#### FINAL BUILDING CODE OF AUSTRALIA 2019 AMENDMENT 1 REPORT

# PROPOSED SENIORS LIVING DEVELOPMENT 36-38 BIRDWOOD AVENUE, PAGEWOOD NSW 2035

Report Ref: BCA Report 22-219444 R02

Date: 2 March 2023

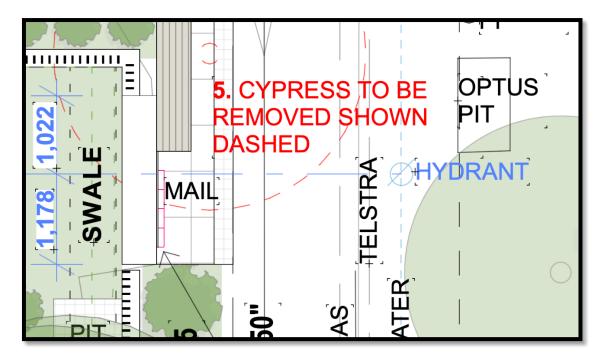
- The space below a required non-fire-isolated stairway must not be enclosed to form a cupboard or similar enclosed space unless the enclosing walls and ceilings have an FRL of not less than 60/60/60 and access doorway is a self-closing -/60/30 fire door (D2.8) **Complies. Sectional drawing confirms no enclosure is proposed under the stair.**

- The construction of stairs, landings, thresholds, barriers, balustrades and handrails must meet the requirements of the BCA. **Detailed elevations to be provided prior to issue of \$6.28 CDVC.**

- Signage should be provided to ground floor exits. The signage should be in accordance with D3.6 of the BCA. *Details to be provided prior to issue of S6.28 CDVC.*

- Fall protection needed to unit bedroom window openings located less than 1.7m high required in accordance with Clause D2.24 **Compliance readily achievable**. **Details to be provided prior to issue of S6.28 CDVC**.
